# City Comments

**Eastside Transit Corridor Phase 2 Draft Environmental Impact Statement(EIS)/  
Environmental Impact Report (EIR)**

The City of Los Angeles Bureaus of Engineering and Sanitation have reviewed the Draft Eastside Transit Corridor Phase 2 project (Project) EIS/EIR's, which proposes alternatives to construct the Mission Junction Maintenance Yard (MJMY) within the City of Los Angeles (City).

# Existing Storm Drains

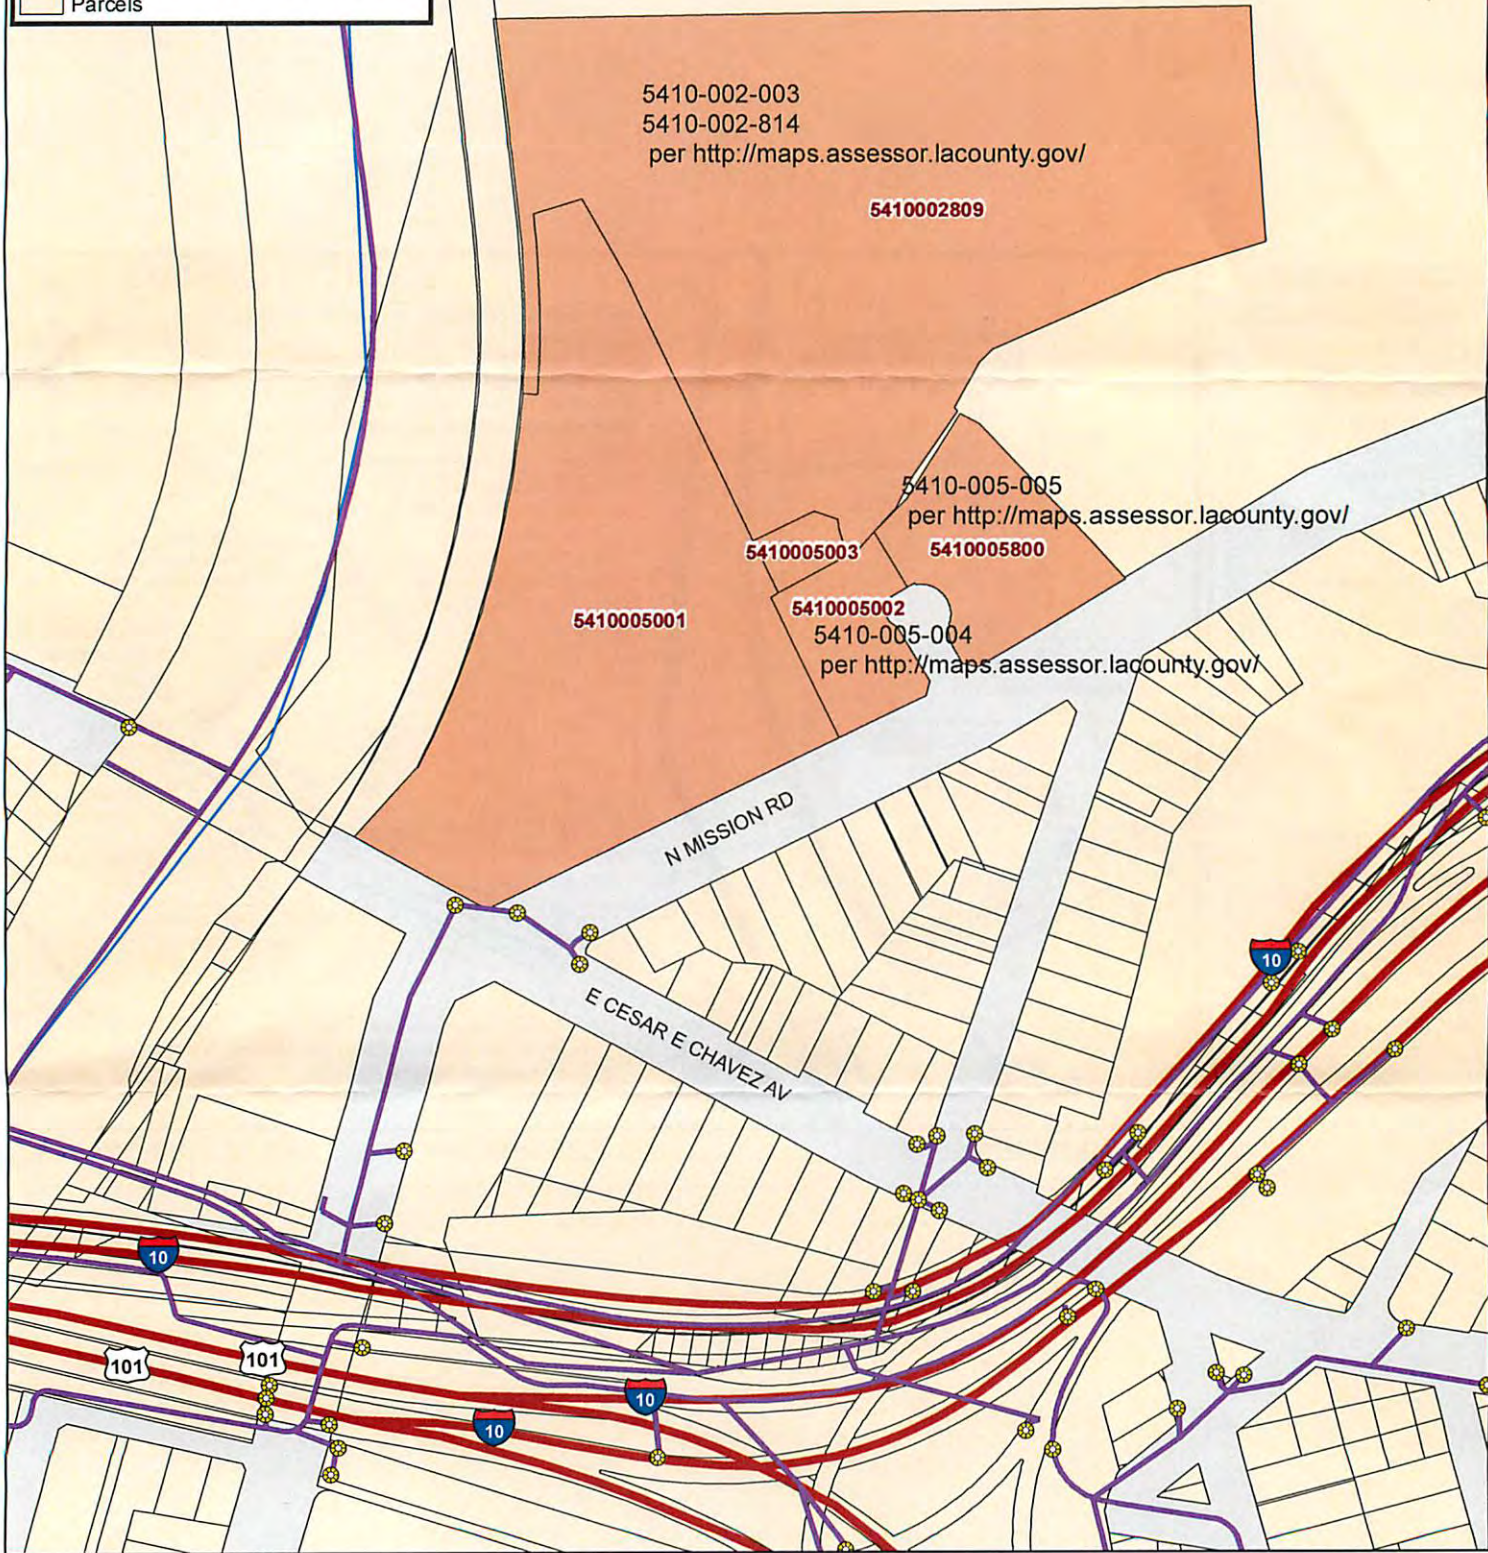
Based on the Project's Draft EIS/EIR, our preliminary findings show that the City has various sewers and stormdrains within and outside of the proposed MJMY site. These existing facilities are shown on the attached sewer and stormdrain GIS maps for your review. In addition to the MJMY option, our understanding is that there are two other sites outside the City of Los Angeles's City limits that are being considered for the Project's future maintenance yard. Once the MJMY site is selected, the MJMY layout should be sent to us for review. Impacts to the City's infrastructure will require the sewers and stormdrains to be relocated, encased, and/or structurally protected with a structural liner.

Exhibit 1 illustrates the proposed Garfield station location and study intersections contained in this analysis.

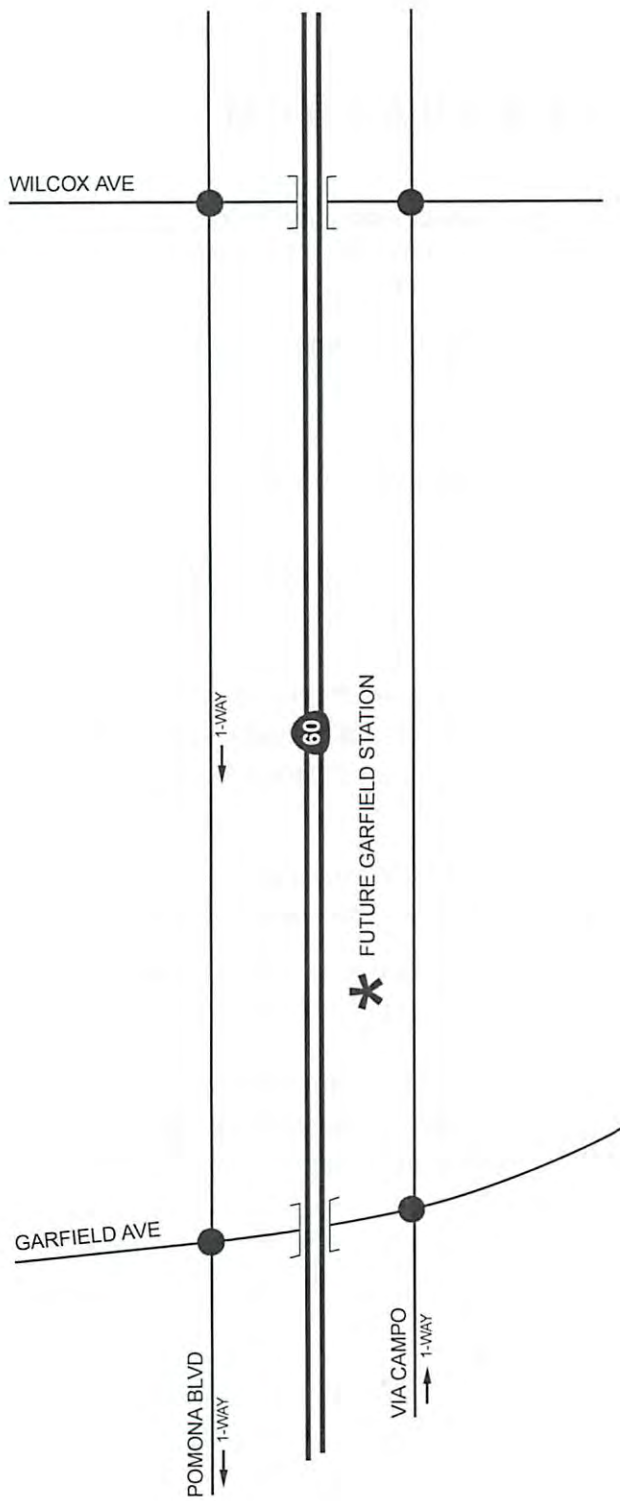
The City has prepared a traffic analysis to determine the potential impacts associated with two Alternatives: 1) the proposed Garfield station park-and-ride facility located on the north side of SR 60 to replace the park-and-ride facility south of SR 60; and 2) a second Garfield station park-and-ride facility located north of SR 60 in addition to the park-and-ride facility south of SR 60. The detailed traffic analysis is provided as an attachment to this comment letter. As anticipated, both Alternatives would increase traffic within the area of the park-and-ride facility at Garfield Avenue and Pomona Boulevard. Although significant impacts would occur under both Alternatives, these impacts can be mitigated by optimizing signal timing splits. Increased vehicular and pedestrian activity would help reinvigorate the South Garfield area and provide much needed visibility and movement within and through the area.

# Existing Sewers

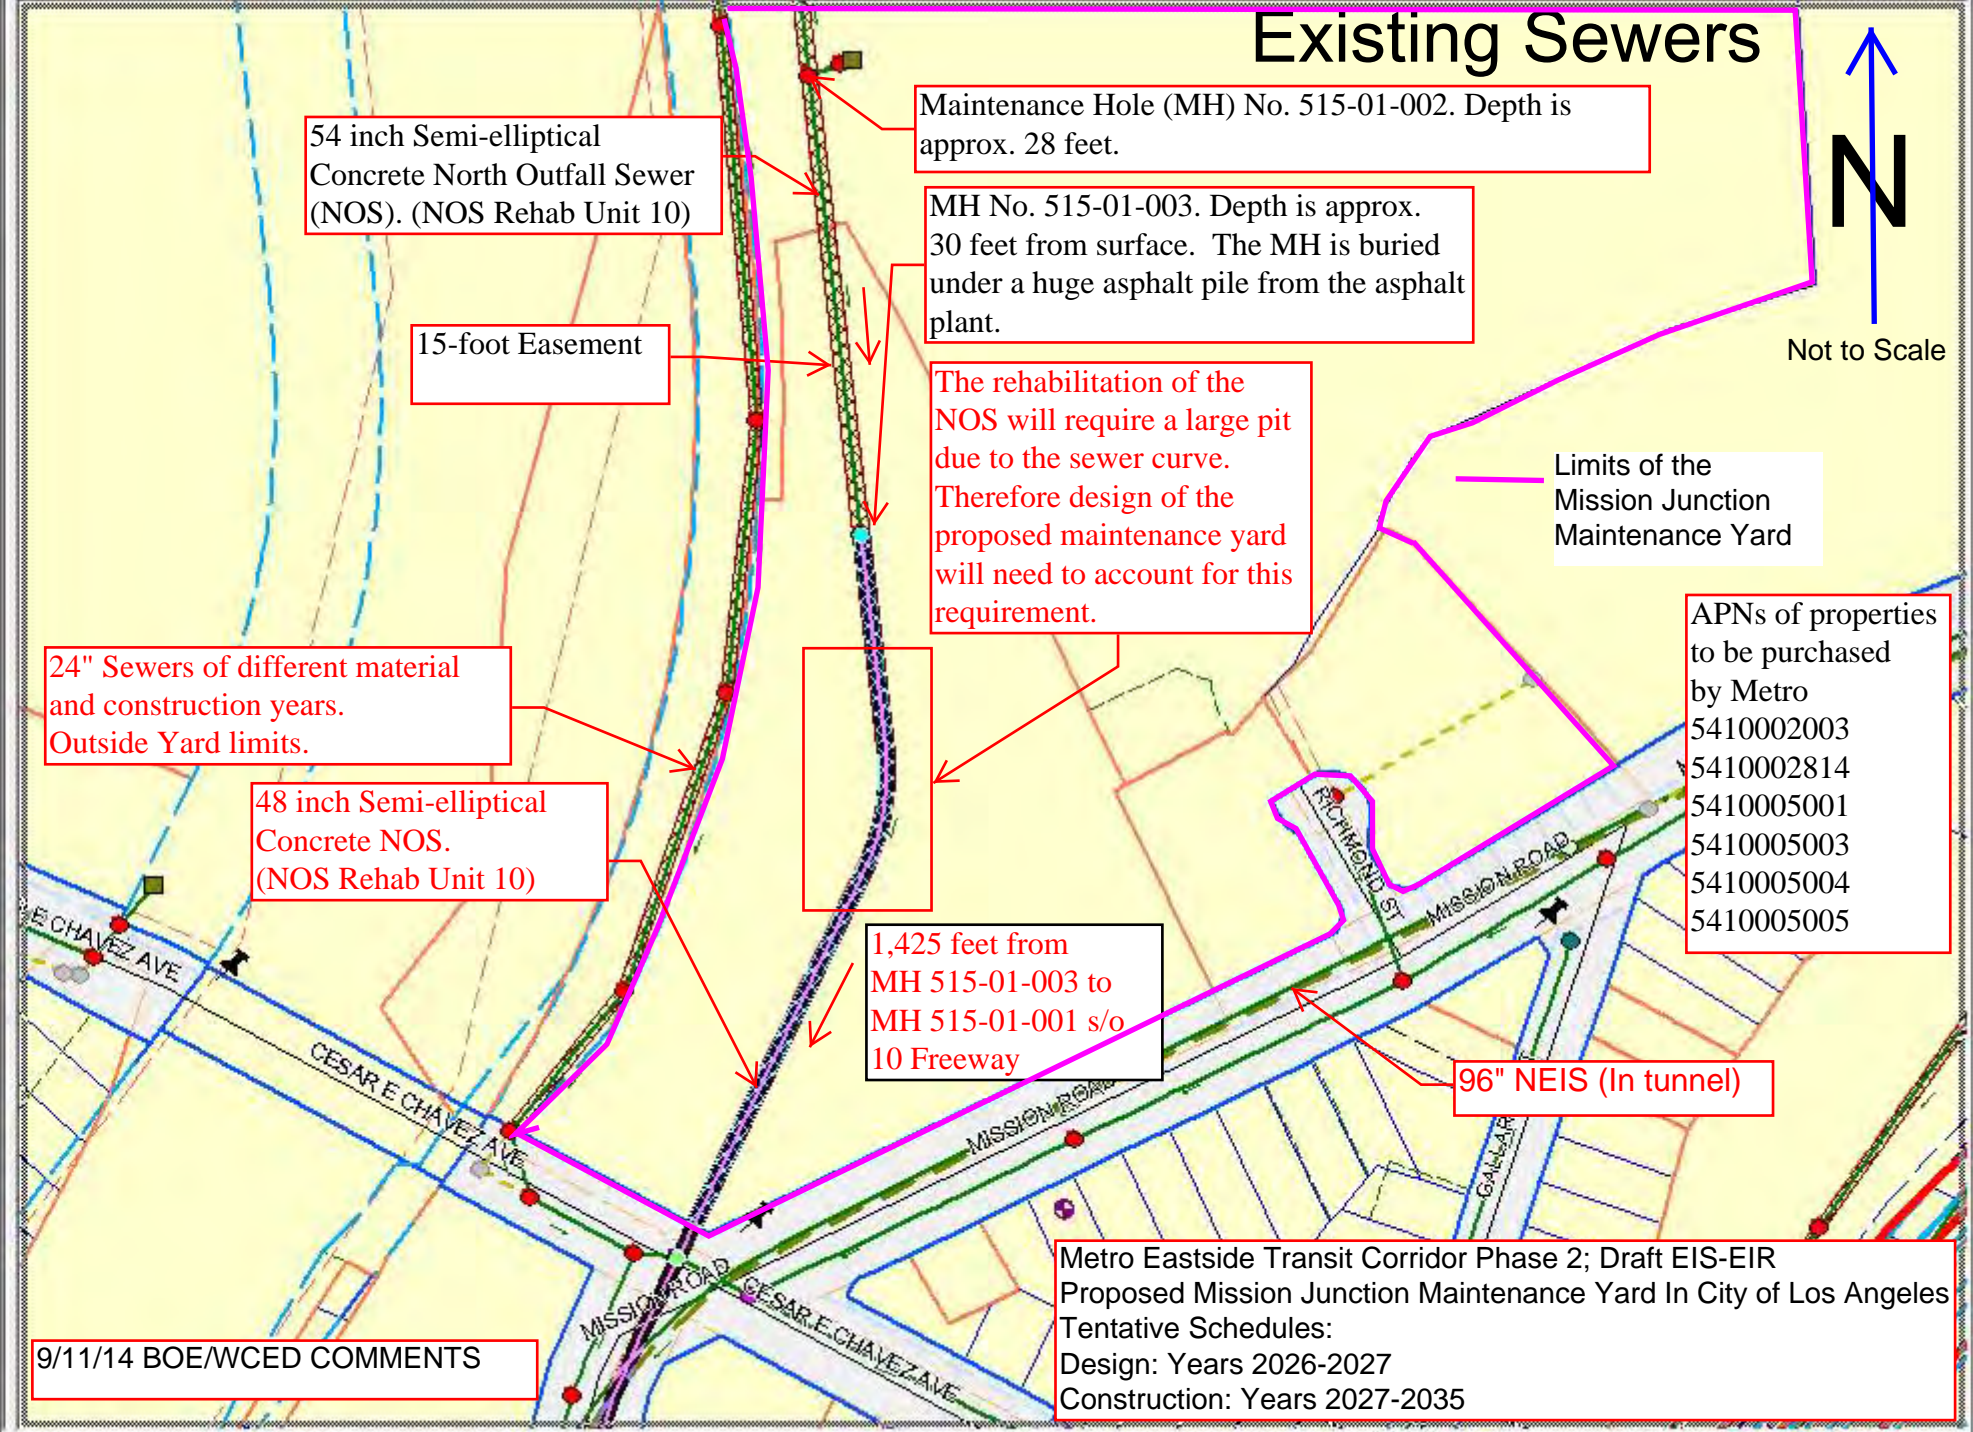
Based on the Project's Draft EIS/EIR, our preliminary findings show that the City has various sewers and stormdrains within and outside of the proposed MJMY site. These existing facilities are shown on the attached sewer and stormdrain GIS maps for your review. In addition to the MJMY option, our understanding is that there are two other sites outside the City of Los Angeles's City limits that are being considered for the Project's future maintenance yard. Once the MJMY site is selected, the MJMY layout should be sent to us for review. Impacts to the City's infrastructure will require the sewers and stormdrains to be relocated, encased, and/or structurally protected with a structural liner.

Figure 5-4. SR 60 LRT Alternative Stations - Zoning

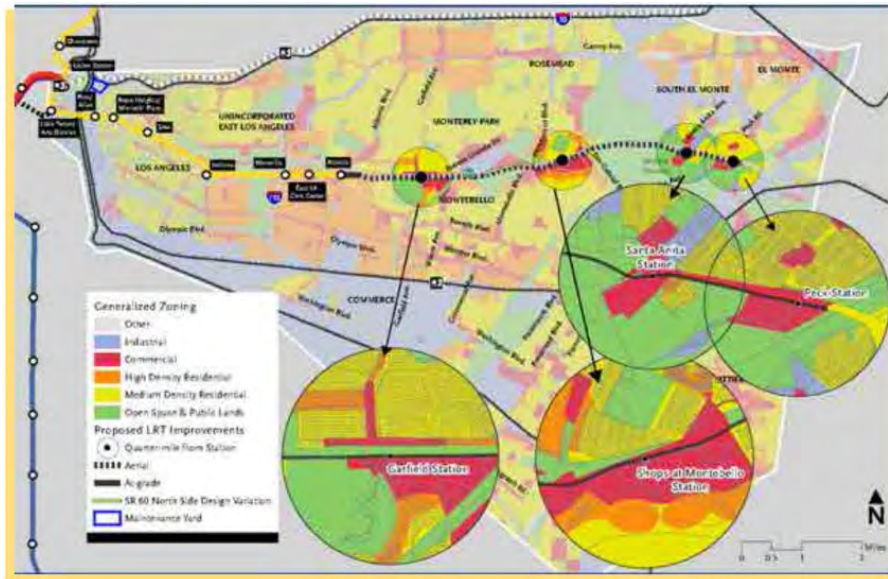
The current zoning for the SR 60 station areas indicates the existence of incompatible land uses. A significant portion of the ½ mile station areas are currently designated “open space & public lands”, shown in green, which are conflicts that reduce the potential for rezoning.

Figure 5-8. Washington Boulevard LRT Alternative Stations – Zoning

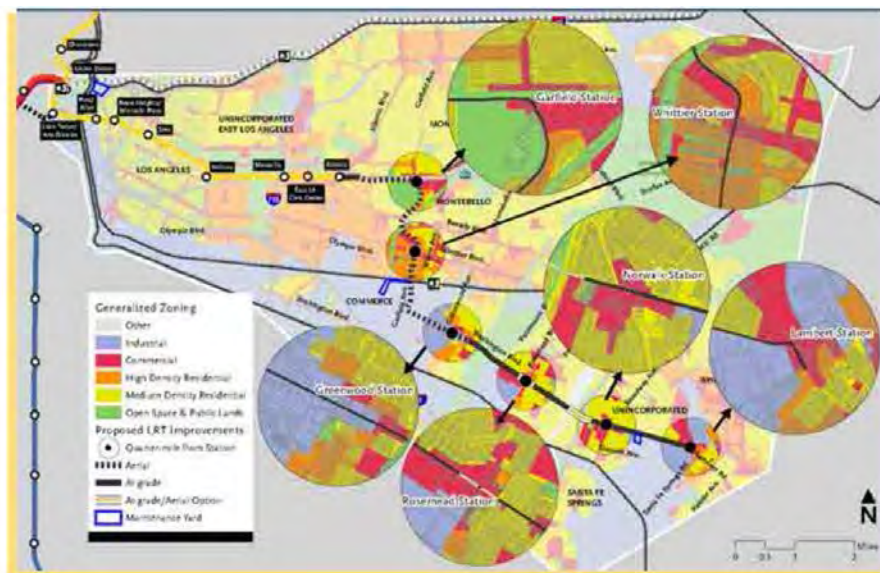
The current zoning map for the Washington Blvd station areas indicates a good mix of allowable uses and intensities, indicating greater potential for revitalization, even under existing zoning.
